Technical	Bulletin	No. RTB-014		
CE Mark Complia	ance	DATE: December 31, '95 PAGE: 1 of 9		
	FROM: 2nd Ted	chnical Support Section		
		MODEL: Interface Kit Type A for DFC - α		
To comply with the CE mark standards, the following modifications have been made to the Interface Kit Type A.				
<ferite core=""></ferite>				
Two ferrite cores are packed with the kit. Please refer to the attached installation procedure of the interface kit for where to use these ferrite cores.				
The mainboard ROMs packed with the interface kit have been standardized with the main board ROM on the copier main board.				
A3996782> A1095104 A3996783> A1095106				
At the same time, the ROMs have been updated from suffix L to suffix M.				
A1095104L> A1095104M A1095106L> A1095106M				
The purpose of this update is to cut the signal from the scanner unit to the IPU when using the copier in scanner mode. This will reduce the amount of electromagnetic emission from the copier.

SUBJECT: Interface Kit Type A CE Mark Compliance

CONTROLLER INTERFACE KIT TYPE-A

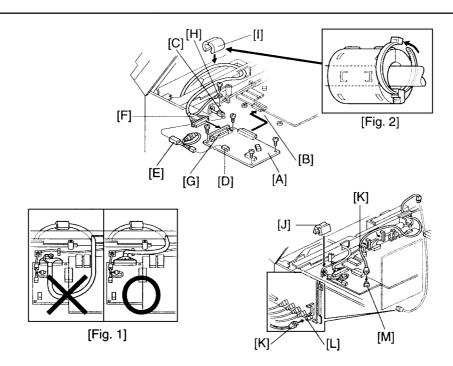
- 12. Install the controller interface board [A] by connecting it to CN308 [B] of the IPU board (4 screws).
- 13. Connect the white 2P connector [C] to CN301 [D] of the controller interface board via the fuse harness [E].
- 14. Connect the controller interface harness [F] to CN303 [G] of the controller interface board. Then secure the grounding wire [H] to the IPU board bracket (1 screw).
 - **NOTE:** 1. Do not route the harness over the board to prevent electromagnetic wave. (See [Fig. 1])
 - 2. Make sure that the connectors are set properly. Otherwise, the copier might not achieve the ready condition or blank copies might be made.
- 15. Install the gray ferrite core [I] and the white ferrite core [J] as shown.

NOTE: Secure the gray ferrite core with the harness band as shown [Fig. 2].
